# Access Compliance Report

## Public Rights-of-Way

### (Curb Ramps)

Intersection ID: 47272	Main Street: LEAHURST_CT	Cross Street: LIDDINGTON_RD	Location: SW
ADA ID: 3C6A055B7694	Ramp Type: PerpDiag	Initial Pass/Fail: Fail	Overall Compliance: No
Codes/Mitigation Info/Possible Solution		Field Measurements/Component Compliance

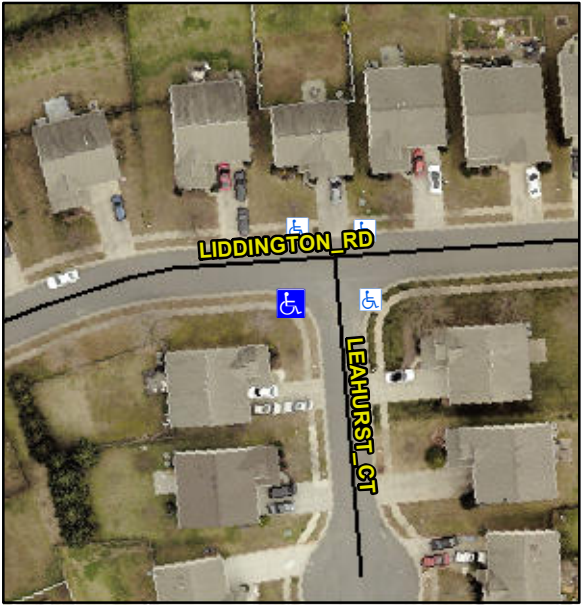
Possible Solutions:			
	Remove & Replace Curb Ramp With Two New Directional Ramps or Equivalent.			
	Surveyor Notes:			
	N/A			
	PROW/ADA:			
	Not Found, R304.5.1, R304.5.3			
Street 1 Name	LEAHURST CT	Compliance	Description	Data
Stop Condition-Street 2	StopSign	N/A	Ramp Length (in)	46.5
Street 2 Name	LIDDINGTON RD	No	Ramp Width (in)	44.0
Stop Condition-Street 1	None	N/A	Flare Type LT	N/A
		N/A	Flare Slope LT (%)	N/A
		N/A	Flare Traversable LT?	N/A
		N/A	Landing Length (in)	N/A
		N/A	Landing Width (in)	N/A
		N/A	Landing Slope (%)	N/A
		N/A	Landing X Slope (%)	N/A
		N/A	Landing Curb? (Y/N)	N/A
		N/A	Shared Landing?	N/A
		N/A	Gutter Ponding?	N/A
		N/A	Gutter Lip Ht (in)	N/A
		N/A	Painted X Walk1?	No
			X Walk 1 Direction	To E
		N/A	X Walk 1 Width (in)	N/A
			X Walk 1 Slope (%)	5.0
			X Walk 1 X Slope (%)	0.4
		N/A	Ramp inside XWalk1?	N/A
			Road Slope (%)	2.1
			Road X Slope (%)	3.7
		N/A	Any Obstructions?	N/A
			Obstruction Type
